Mark Howe
Business Support Services Officer
Mining Regulation and Rehabilitation Branch
DMITRE
GPO Box 1264
Adelaide SA 5001

Re: Kara Resources Mining Lease MC4322 - Letter of objection and request for further information

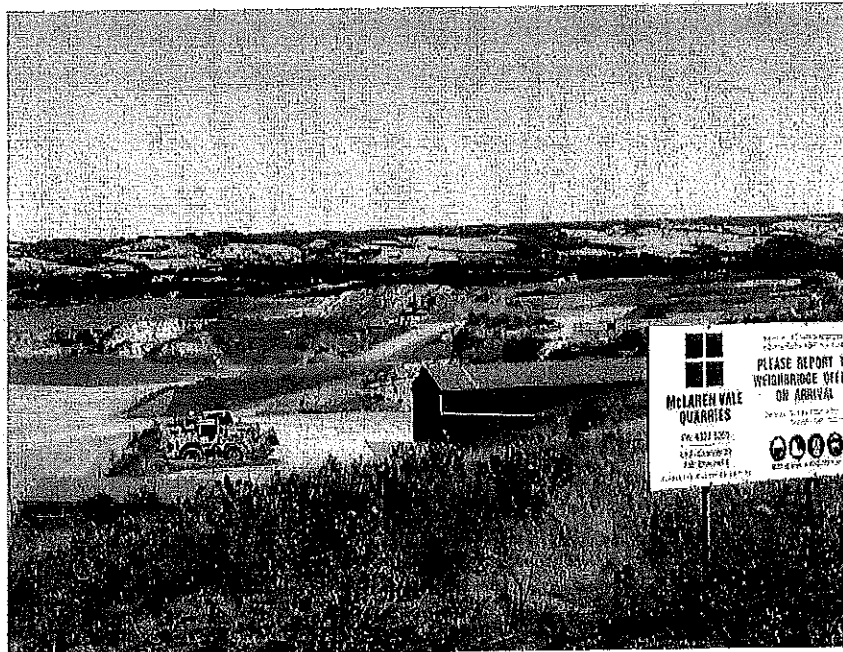
- vi. In 2.9.3 page 21 the report states "It is likely that eventually 60-200 trucks per week will access the site".

- This clearly allows for one way trips.
- 400 trucks per week on return trips is a huge increase of traffic
- The reason residents purchased property in the area is BECAUSE the road use is limited and the area is quiet and peaceful

- We contend that on their upper range of production tonnage per day of 2000 tonne carted out by 30 tonne payload trucks would equal 66.7 full loads going out every day.

- This is 133 in and out truck movements per day
- Plus support vehicles and workers personal vehicles
- With existing movement and adding this traffic, we would estimate this would add up to 160 plus movements on the road

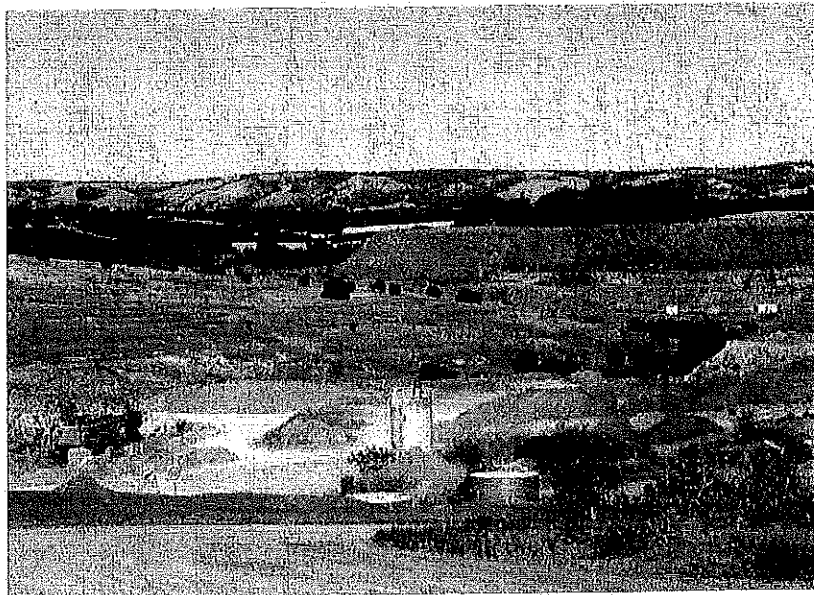
- ii. The risk matrix indicates a negligible likelihood and a cat 2 rare low effect
 - iii. Please provide documented evidence for the premise that quarrying noise levels are miniscule to those generated by farming and public use of roads? 'Noise levels over 85db require ear

muffs thus the projected noise level of close to 110Db will be damaging to residents in the area and negate the claim that it is 'miniscule'
